Inter Tribal Association of Arizona

May 31, 2022

Re: Inter Tribal Association of Arizona's Comments and Objections to ADEQ's Renewal and Amendment of the Resolution Copper Mining AZPDES Permit No. AZ0020389 (LTF No. 90471)

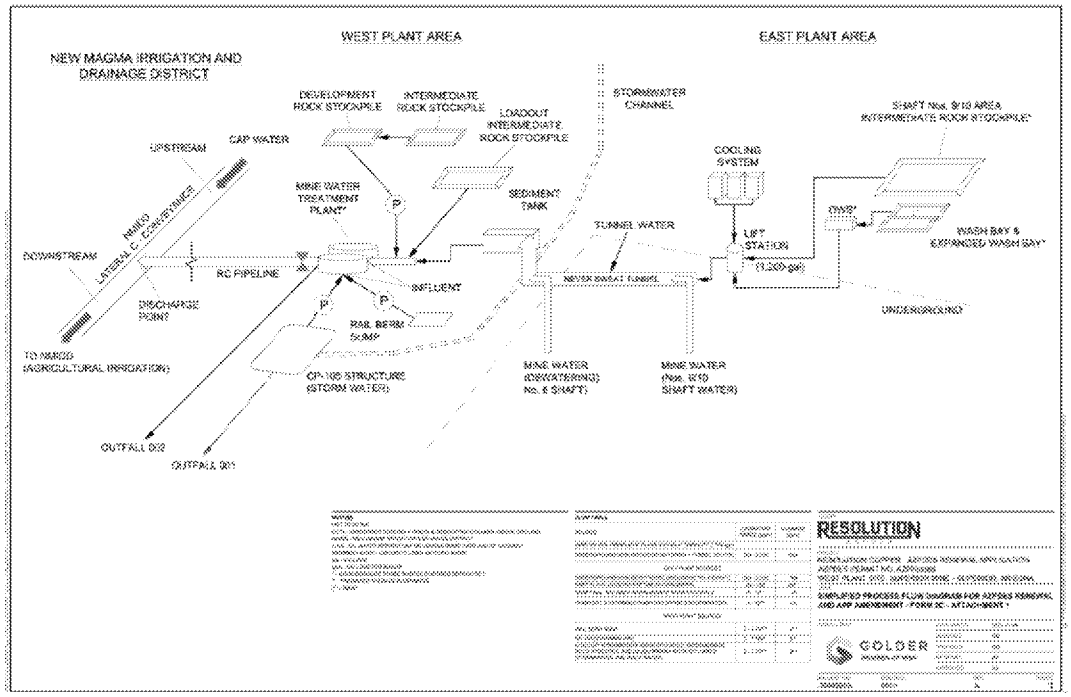
The Process Flow Diagram (shown on the following page) and Site Drainage Maps attached to the AZPDES Renewal Application[9] indicate that stormwater from across the West Plant site drains to and is collected in Collection Pond No. 105 (CP-105, formerly "Indian Pond") where it can then be discharged through Outfall 001. The West Plant Site is located north of Highway 60 in Superior, just north of Queen Creek, and drains south towards Queen Creek.

In sum, there are multiple sites located across the West Plant site which have the potential to convey pollutants and other constituents of concern into Queen Creek via discharge of stormwater at Outfall 001.

One key ongoing component of this remediation work is continued surface water monitoring, and a demonstration that the contamination source will not cause or contribute to an exceedance of surface water quality standards. A.R.S. § 49-175(B)(3).[11] Given the historic contamination from mining activities in the area, as well as ADEQ's duties under its administration of the AZPDES program, obtaining data on the quality of stormwater which could be drained into CP-105 and discharged through Outfall 001 is a key task.

However, Resolution notes that data on the quality of the stormwater which could be discharged through Outfall 001 "has not been obtained."[12] It also does not appear to be in the process of being obtained. Form 2F (dated July 22, 2021 at p.3, attached to AZPDES Permit Renewal Application) at Section 5.2 states: "No discharge through Outfall 001 has occurred therefore, no discharge data is available. Certification based on absence of active operations, completion of extensive reclamation work, diversion and containment control measures, and ability to pump water to MWTP." ADEQ appears to see no issue with this, since ADEQ did not require any additional information from Resolution Copper on this matter and they apparently failed to obtain this data independently.

The East Plant Site is east of the Town of Superior. The Process Flow Diagram (shown on the prior page) indicates that waters from various sources at the East Plant Site are collected and transported to the Water Treatment Plant at the West Plant Site through the Never Sweat Tunnel.

The Application at Form 2C(I) states that contributing flows to Outfall 002 come from "Various Combined Sources" such as "mine dewatering, stormwater, etc." and references an attachment. Yet, the attachments do not distinguish, or specifically list these various sources. Furthermore, there is no evidence from the materials we have reviewed that any sampling of the feed water from these various sources has occurred.

Given that stormwater in CP-105 may be discharged to Queen Creek via Outfall 001 without treatment, ADEQ must obtain and fully review baseline water quality data for the potential discharge at Outfall 001 post-reclamation to ensure compliance with the discharge limits imposed by the AZPDES permit. This is fundamental and nothing less than this should be permitted. It is also critical that the water quality data be developed on the influent to assure the successful operation of the MWTP. This is also a critical task, since the failure to fully apprehend the nature of the influent can result in treatment plant failure and a noncompliant discharge.

ADEQ should require that robust feed water quality data from these "various combined sources" at the East Plant Site be collected and analyzed for purposes of this permit. Data on the inflow into MWTP is essential to the ongoing functionality of the MWTP. ADEQ's failure to require this information is inconsistent with their mission and obligations in administering the Clean Water Act.
